# Interactive comment on "Imaging tropical peatlands in Indonesia using ground penetrating radar (GPR) and electrical resistivity imaging (ERI): implications for carbon stock estimates and peat soil characterization" by X. Comas et al.

#### X. Comas et al.

Received and published: 17 April 2015

Fig. 2.

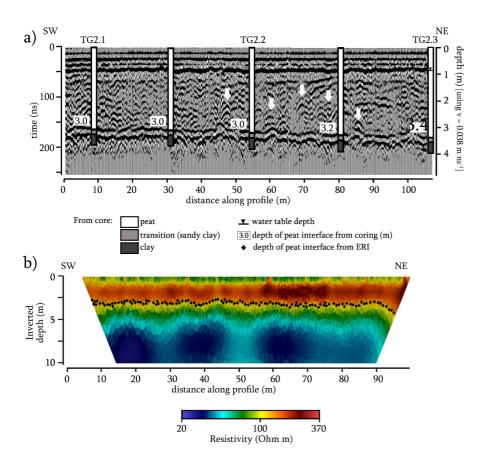
- 7. Figure 2: What is "woody layers?"? In order to avoid confusion, the term "woody layer" in Figure 2 has now been replaced with "woody area" as explained in the text (section 4.1).

- -8. Figure 2 and 5, 6: Water table elevation is water table depth "Water table elevation"

has been replaced with "water table depth" in all figures.
